Gaskell Planning Consultants

RE: SUMMARY OF SUBMISSIONS RECEIVED DURING PUBLIC NOTIFICATION AT 17 GUNNER STREET, KEDRON QLD 4031 AND DESCRIBED AS LOT 3 ON RP77165 (APPLICATION REFERENCE: A007067229)

RECONFIGURING A LOT (1 LOT INTO 2 LOTS)

Figure 1: Small and narrow lots in the surrounding area

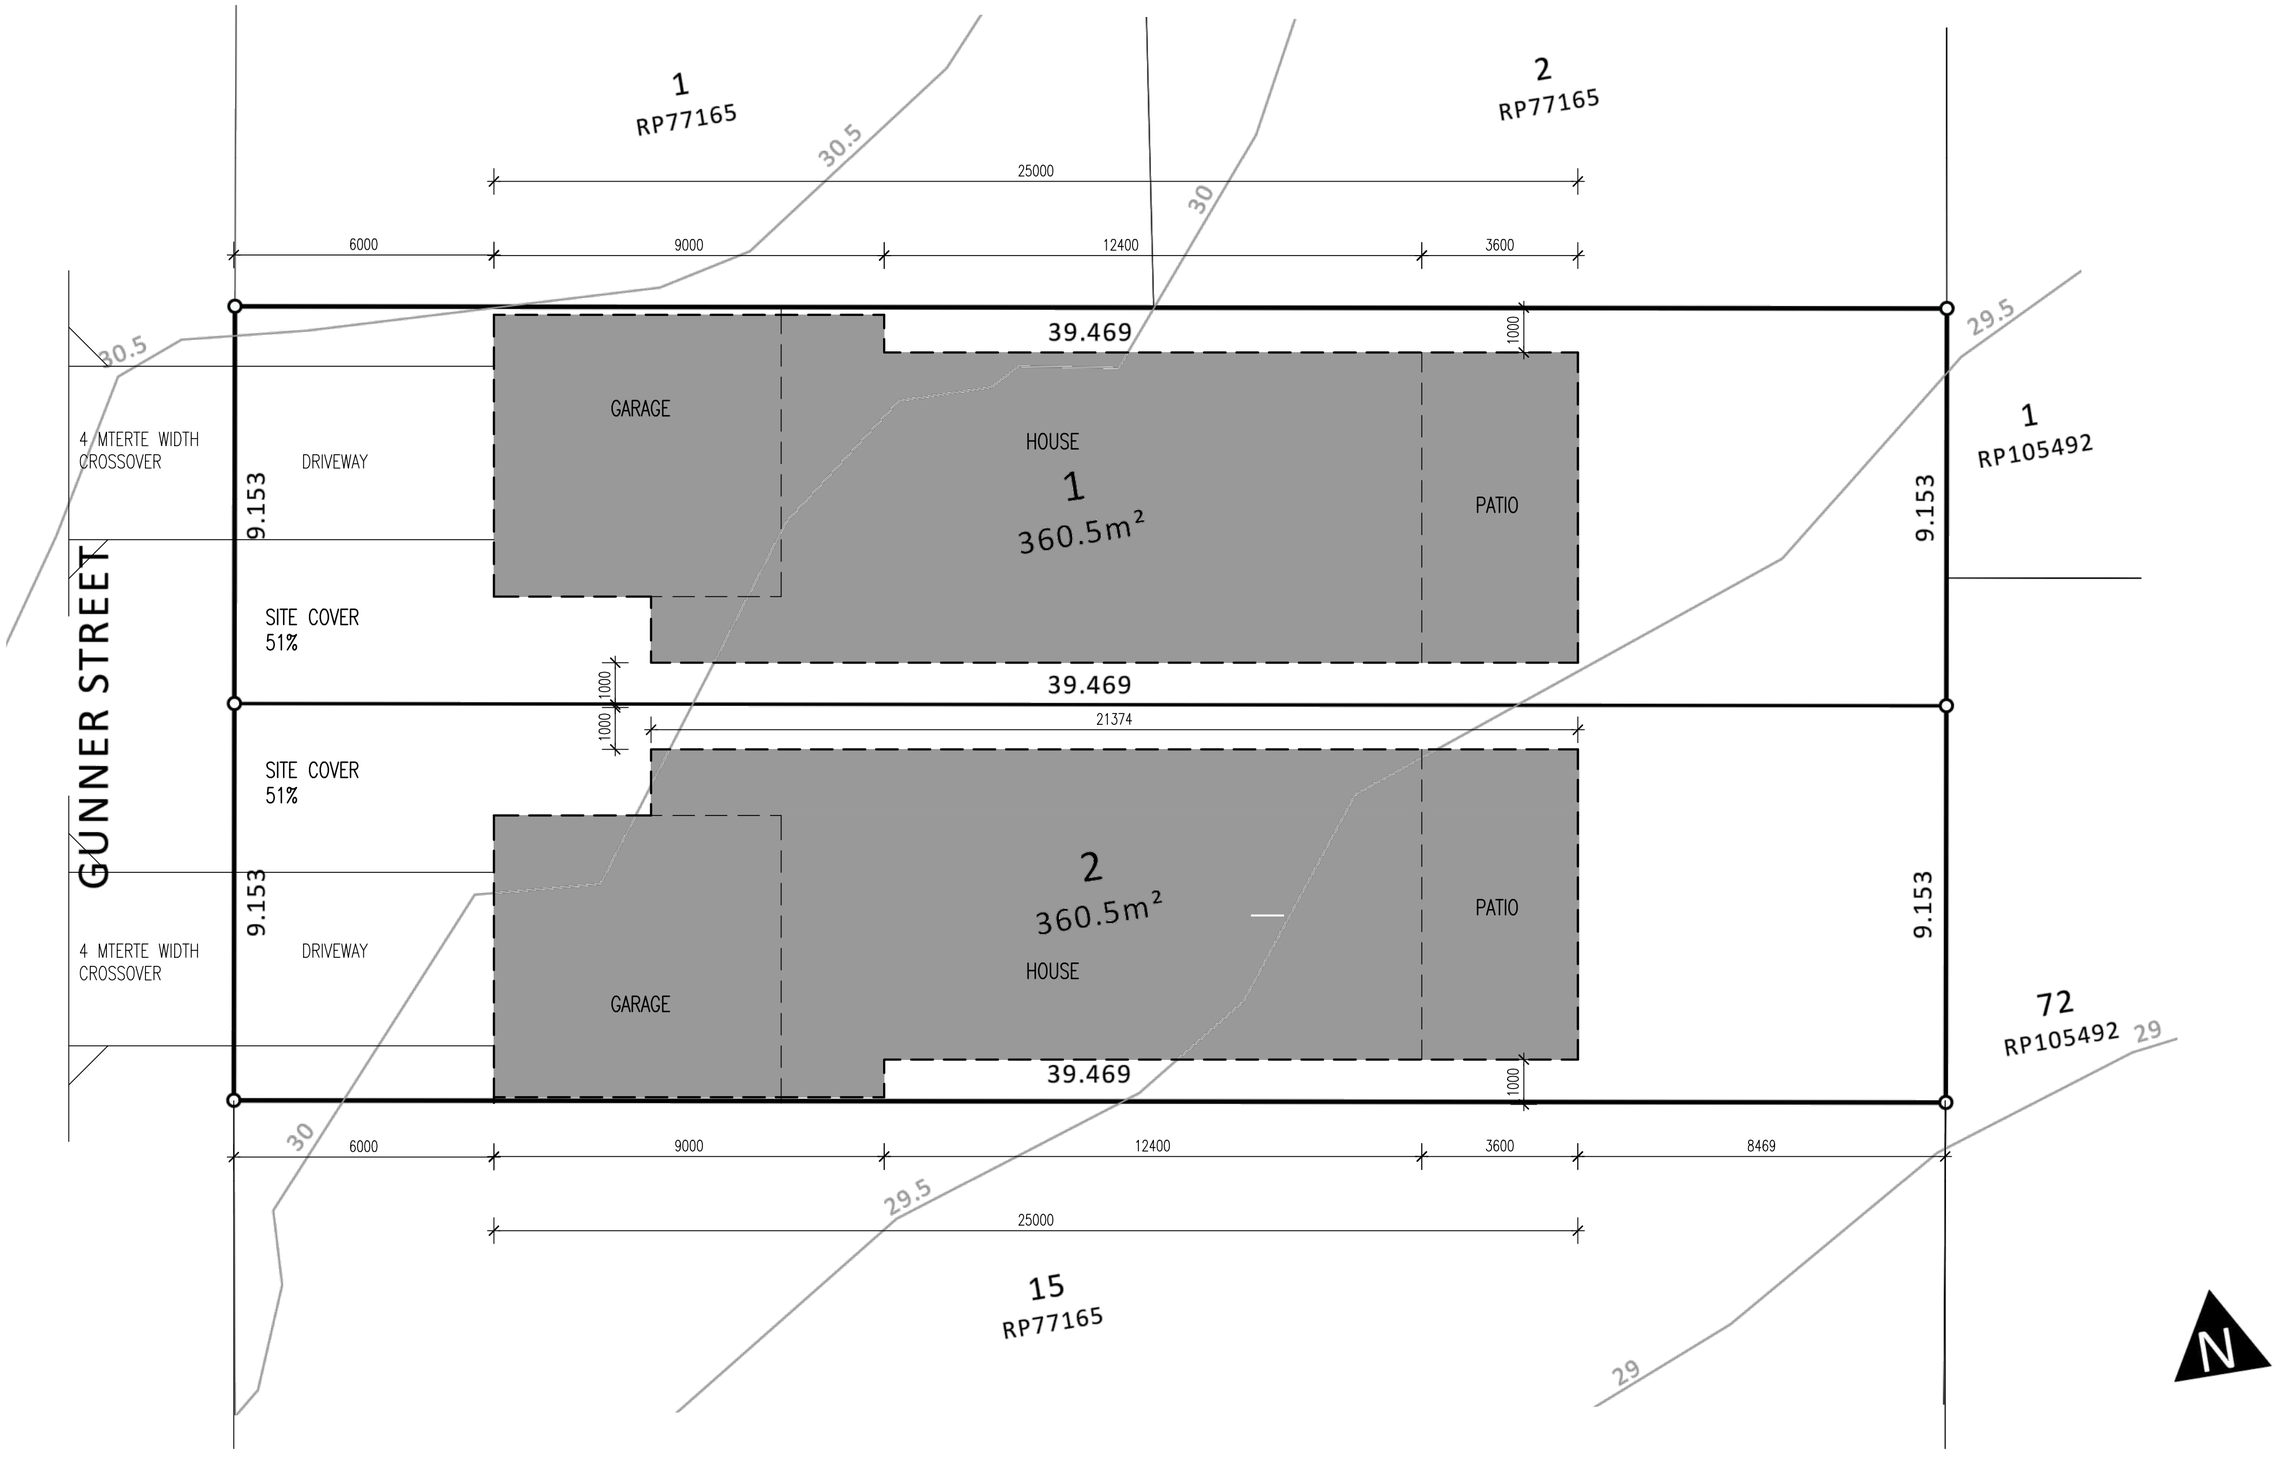
- Lots that are not a sufficient size to accommodate a suitable building envelope including compliant setbacks, site cover and separation from adjoining dwellings

- Impacts on privacy and amenity of adjoining residents due to building separation and overlooking
- Homes sitting substantially higher than surrounding properties due to elevated building platforms
- Reduced opportunities for landscaping and mature trees and the loss of the traditional backyard
- Narrow lots do not reflect the traditional character and established subdivision pattern of the locality
- A built form that does not align with the prevailing scale, spacing and setting of existing dwellings.

The proposed development does not create constrained or unusable lots which will require excessive concessions at the building approval stage. Lots of this size and scale are increasingly common across SEQ and there are many examples, including within a 2 block radius of the subject land where it can be demonstrated that small lots can suitably accommodate a dwelling house while retaining open space for recreation and landscaping, refer to **Figure 1.**

In fact, the original subdivision of the surrounding area reveals a large number of 10m wide lots and indicates that the initial intent for the area was that the majority of lots were less than 14m wide. This is evidenced by a number of the pre-1946 homes (particularly on Wood Street and Somerset Street) being located over two property titles.
